STAFF RECOMMENDATION
1503 Clayton Avenue
September 19, 2018

Application: New Construction-Addition
District: Belmont-Hillsboro Neighborhood Conservation Zoning Overlay
Council District: 17
Map and Parcel Number: 11708017900
Applicant: J. Seth Jennings
Project Lead: Melissa Sajid, melissa.sajid@nashville.gov

Description of Project: The application is for a rear addition. **Recommendation Summary:** Staff recommends approval with the following conditions: **1.** Staff approve the final foundation material, secondary cladding material, roofing color, porch columns, porch steps, and porch floor, prior to purchase and installation; and, **2.** The HVAC shall be located behind the house or on either side, beyond the mid-point of the house if relocated. With these conditions, staff finds that the addition meets Sections II.B.1. and II.B.2. of the Belmont-Hillsboro Neighborhood Conservation Zoning Overlay.	**Attachments** **A:** Photographs **B:** Site Plan **C:** Elevations

Figures 2 and 3: Covered rear porch that is to be enclosed (left) and 1957 Sanborn map (right)

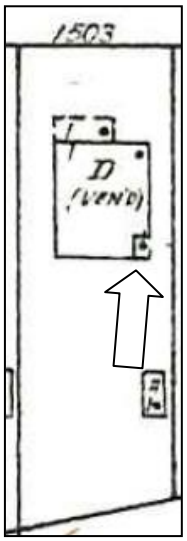
Partial demolition: The application proposes to enclose an existing covered porch on the rear façade that appears on the 1957 Sanborn map and is likely original to the house (Figures 2 and 3). Staff finds that enclosing the covered porch is appropriate because this portion of the house is not visible from the public right of way and does not contribute to the historic or architectural character of the overlay. The proposed partial demolition meets Section V.2 for appropriate demolition and does not meet section V.1 for inappropriate demolition.
